RANCHO SANTIAGO COMMUNITY COLLEGE DISTRICT

ADDENDUM NO. 2

Bid #1506
ORANGE EDUCATION CENTER PORTABLES PHASE II
at
ORANGE EDUCATION CENTER

Project ID #3762, DSA #04-125366

**WAY FINDING
SIGNAGE SITE PLAN**

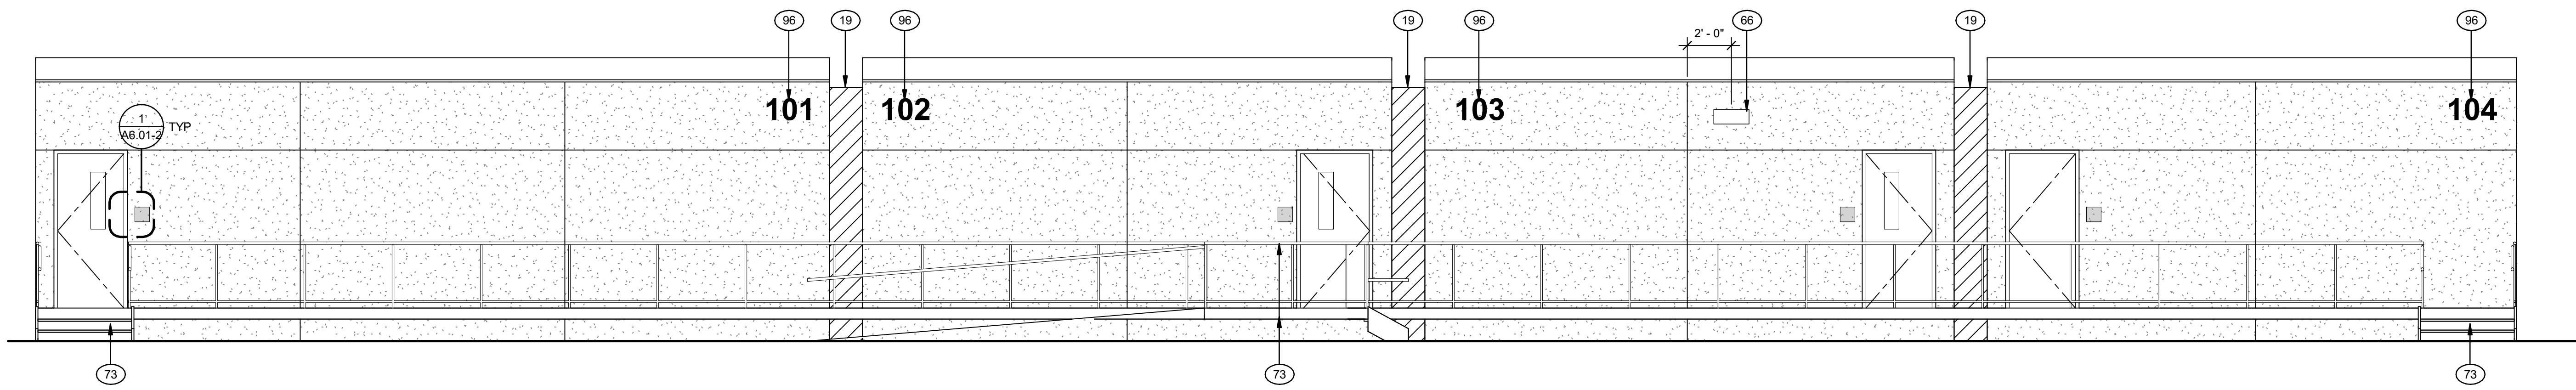
3. A1.03-2, WAY FINDING SIGNAGE SITE PLAN

Added Addendum Dwg. A1.03-2, Way Finding Signage Site Plan

EXTERIOR ELEVATION
PORTABLE 101 - 109

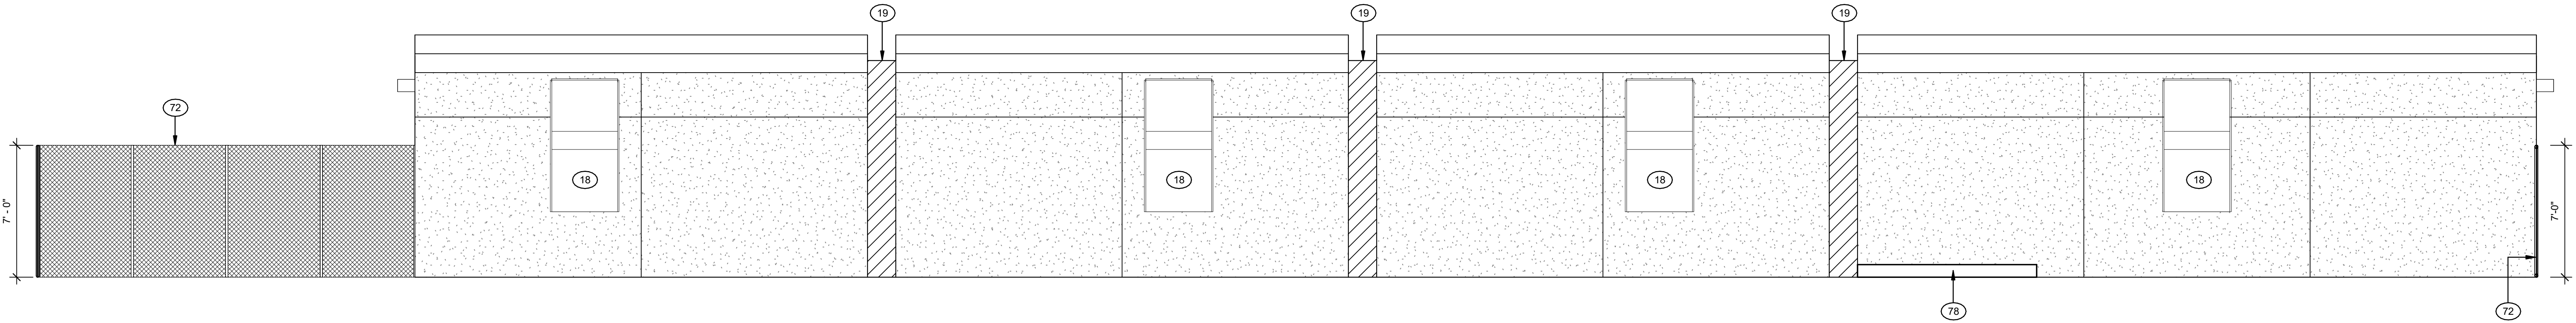
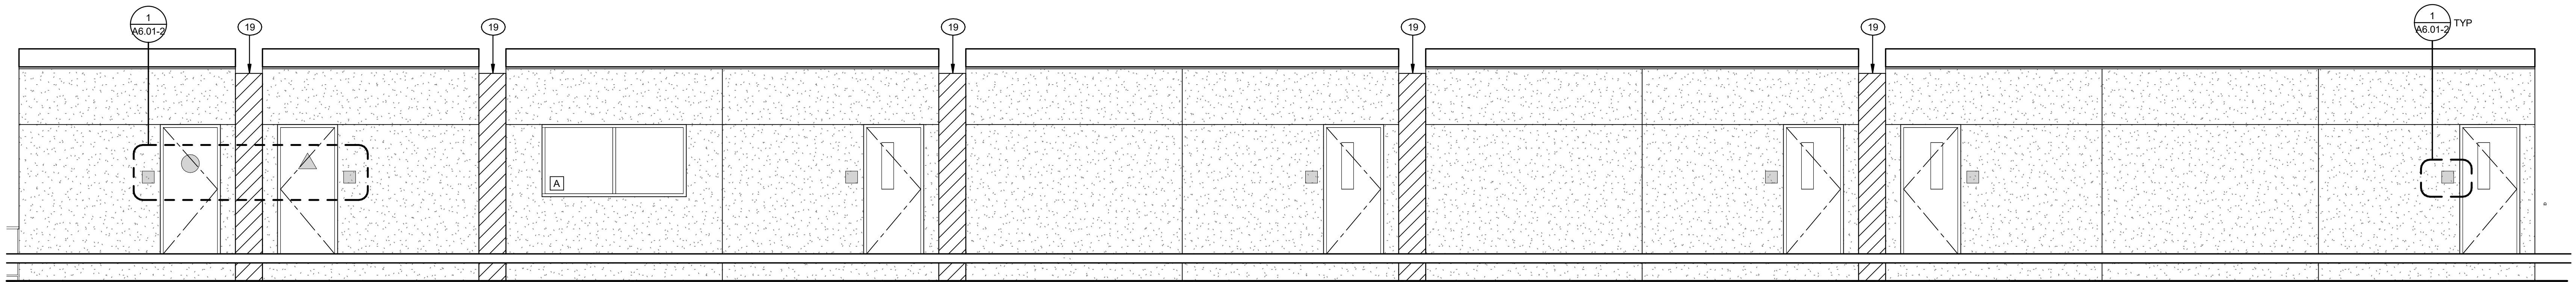
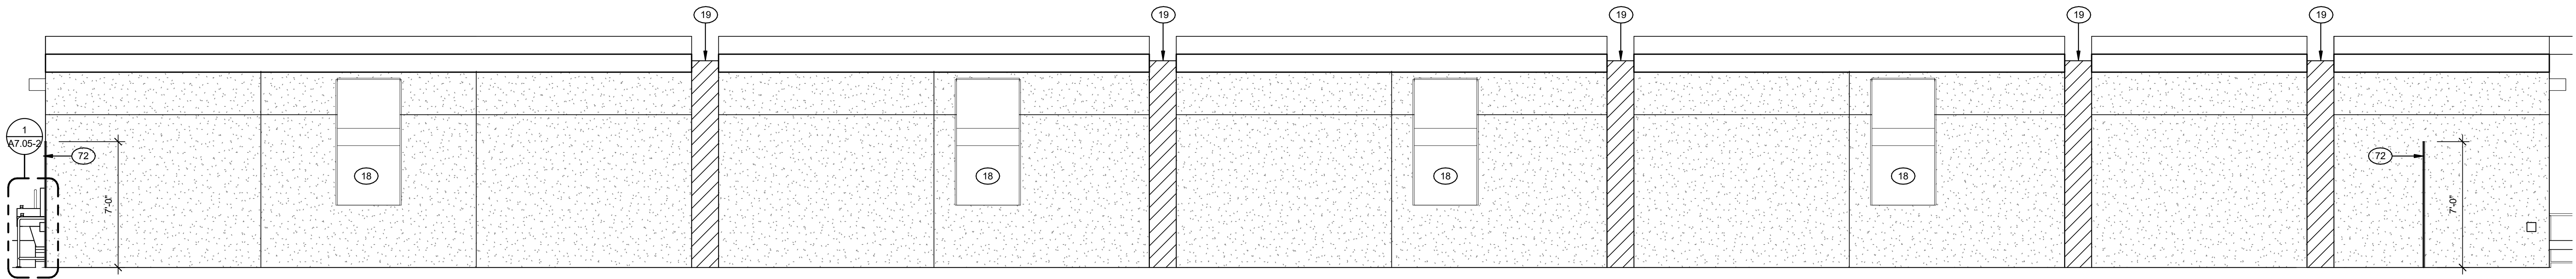
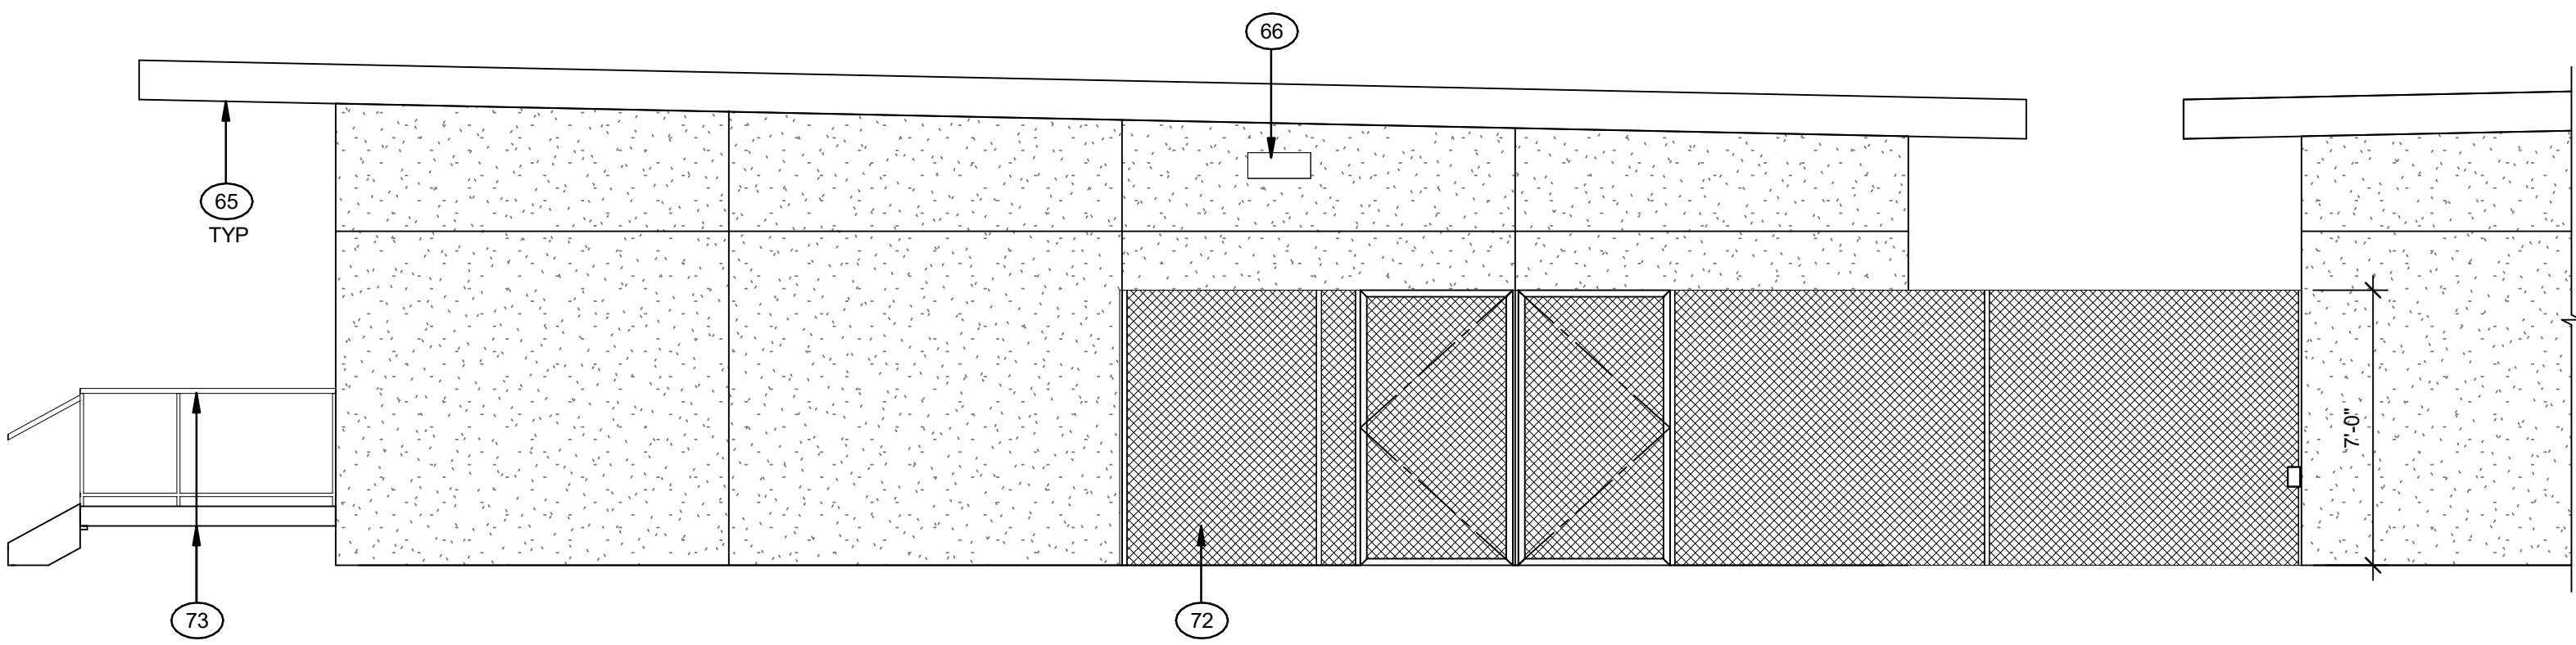
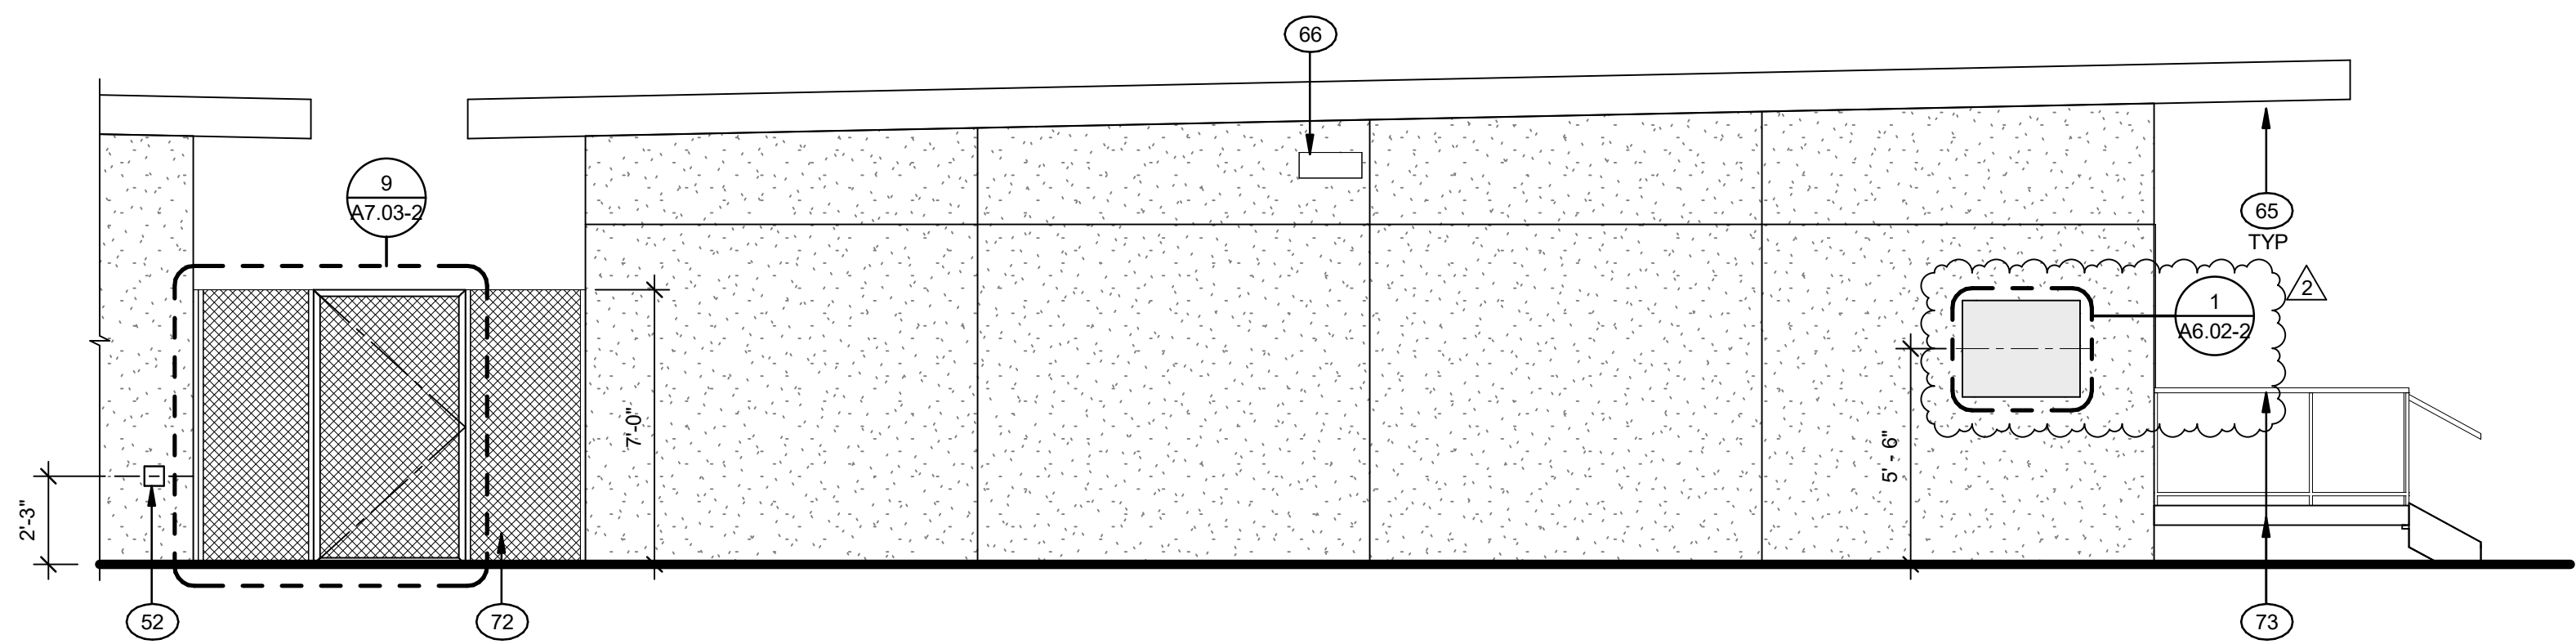
4. A3.01-2, thru A3.06-2, EXTERIOR ELEVATION PORTABLE

Added way finding signage.
